STATE OF FLORIDA
DIVISION OF ADMINISTRATIVE HEARINGS

IN RE: FLORIDA POWER AND LIGHT COMPANY
TURKEY POINT UNITS 6 & 7
POWER PLANT SITING APP. PA03-45A3

DOAH Case No. 09-03575-EPP
DEP OGC Case No. 09-3107

**Miami-Dade County Agency Report and Proposed Conditions for FPL Proposed
Transmission Lines for Turkey Point Nuclear Units 6 & 7
January 17, 2012**

FIGURE 1

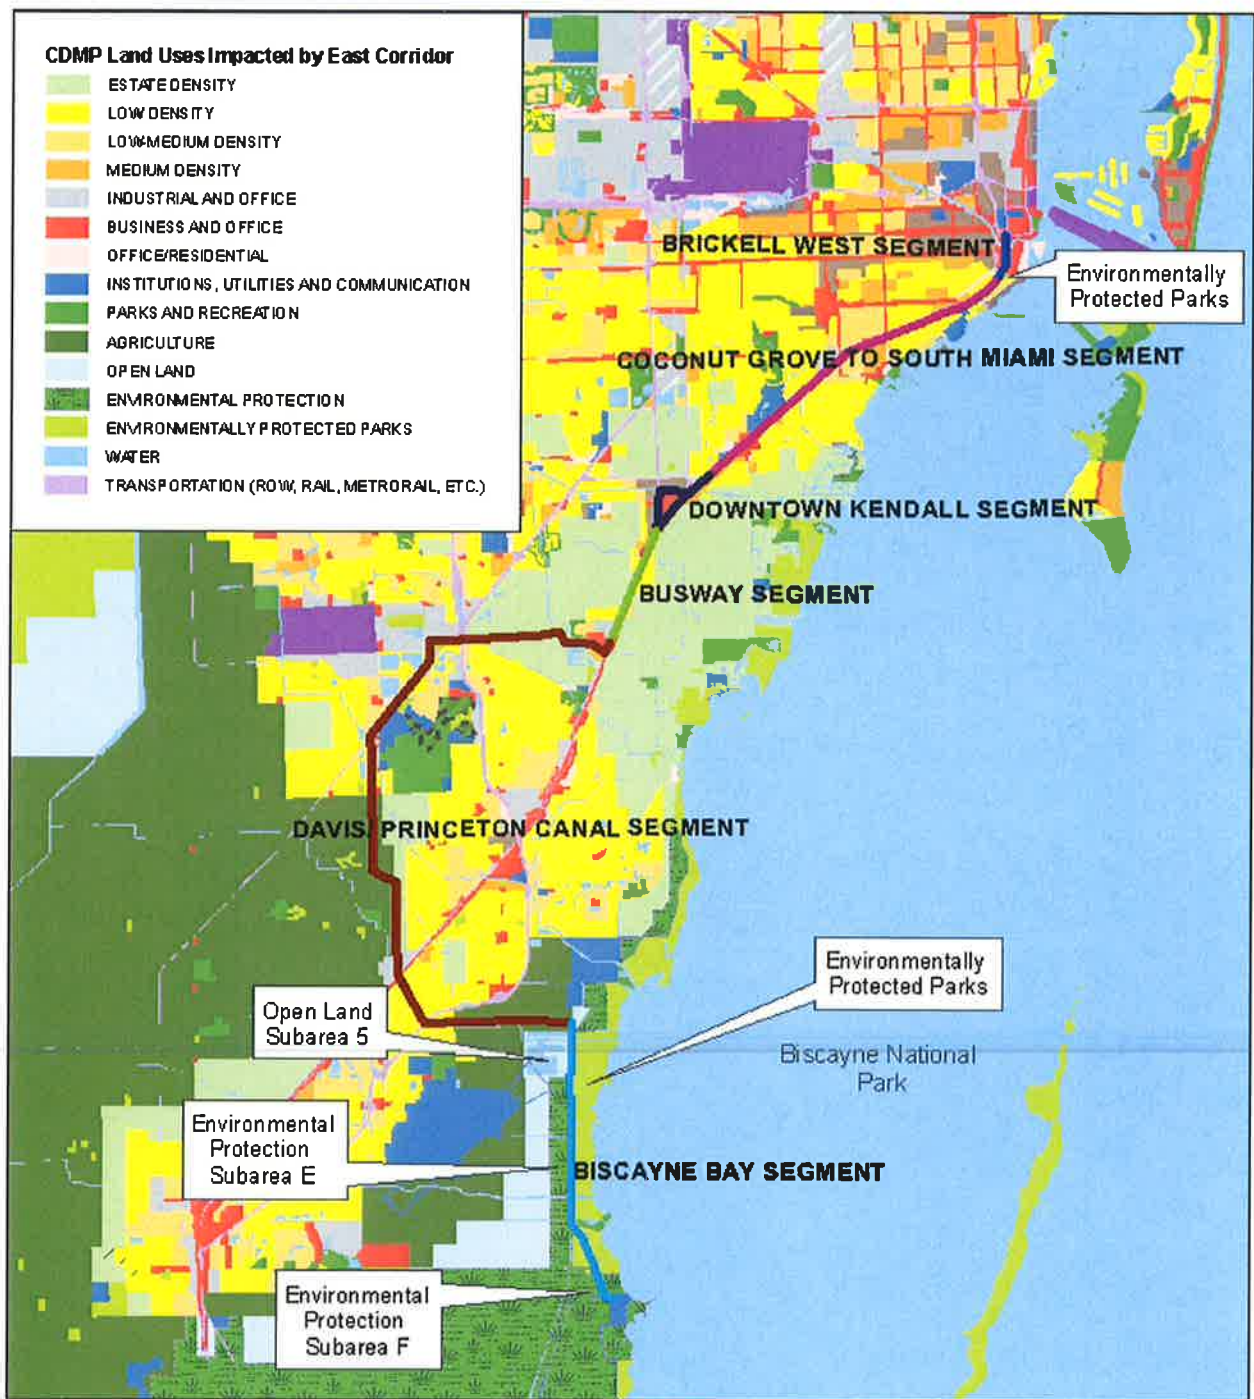
FPL's proposed eastern corridor has been divided into segments to organize the description of impacts and conditions based upon County Code provisions which apply to defined geographic locations and distinct CDMP text, policies, and CDMP land use map categories with different allowed uses. In some cases, conditions apply to multiple segments of the Eastern Corridor. The Figure 1 below depicts relevant CDMP land uses and transmission line segments described in narrative form throughout this section of the report. From north to south the proposed 230kV Eastern Corridor transmission line would extend roughly 36.7 miles according to Site Certification Application materials submitted to the County for this project. The subsections below include conditions designed to address potential impacts relevant to the Eastern Corridor including specific segments of the corridor.

FIGURE 3

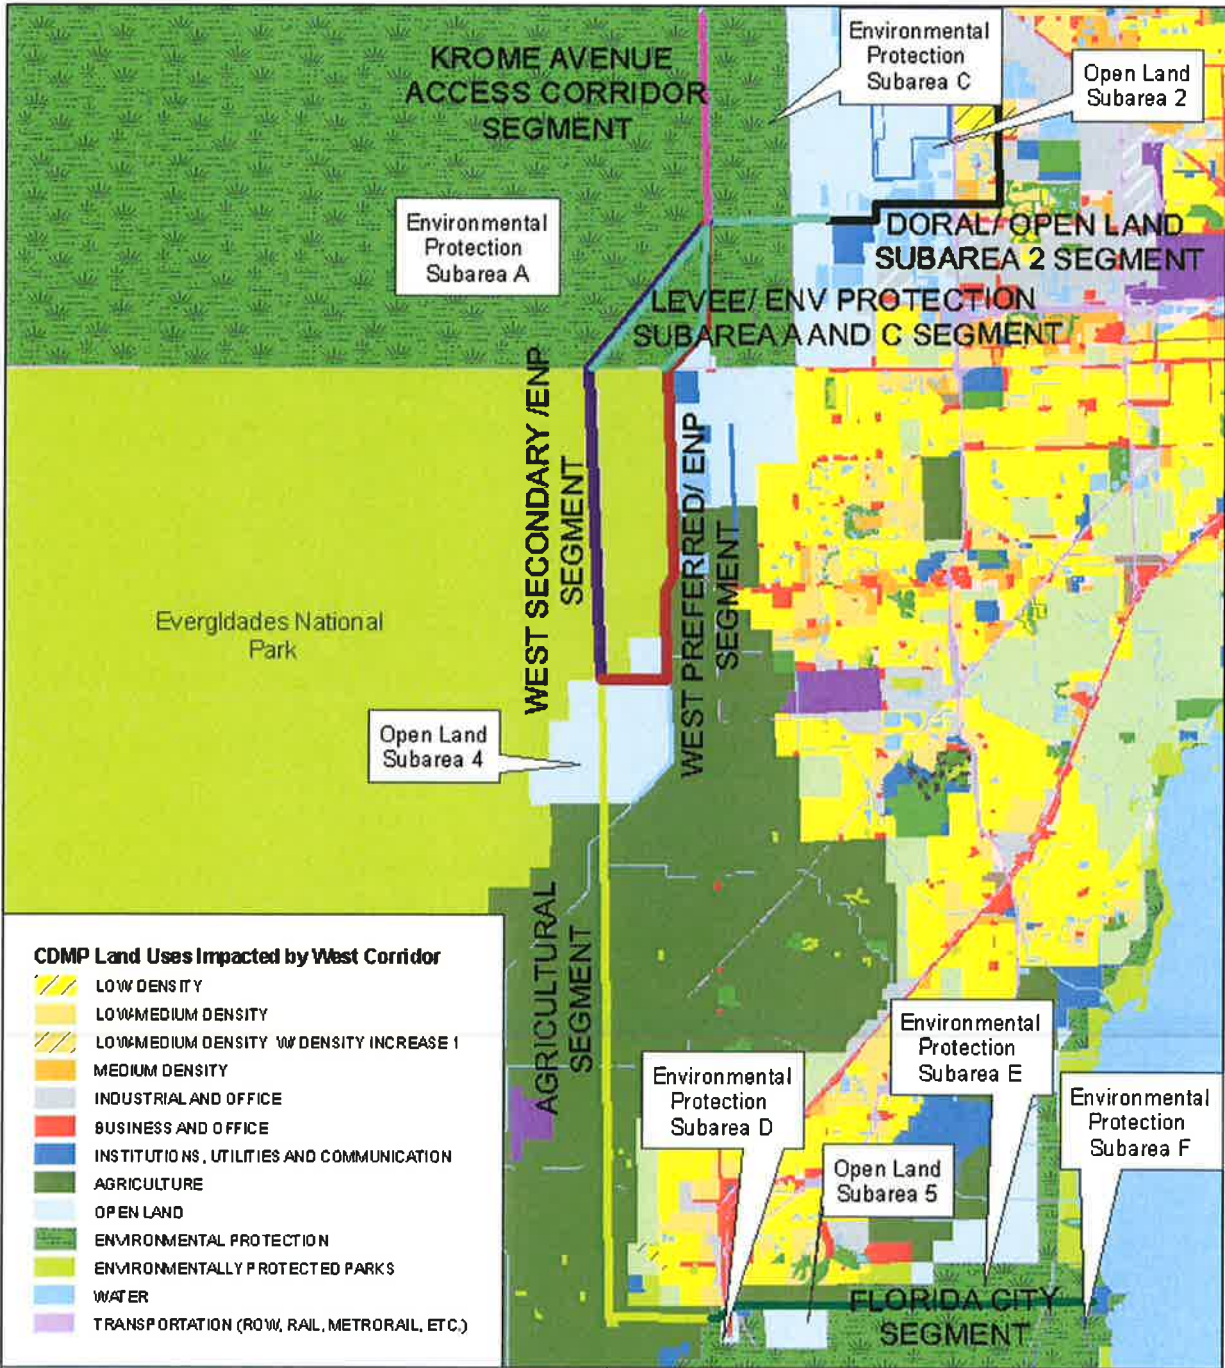
FPL's proposed western corridors have been divided into segments to organize the description of impacts and conditions based upon County Code provisions which apply to defined geographic locations and distinct CDMP text, policies, and CDMP land use map categories with different allowed uses. The Figure 3 below depicts relevant CDMP land uses and transmission line segments described in narrative form throughout this section of the report. From north to south the two proposed 500kV Western Preferred Corridor transmission lines would extend roughly 43.6 miles and the proposed 230 kV line would extend roughly 52 miles, according to Site Certification Application materials submitted to the County for this project. The subsections below include conditions designed to address potential impacts relevant to the Western Corridors including specific segments of the corridor.
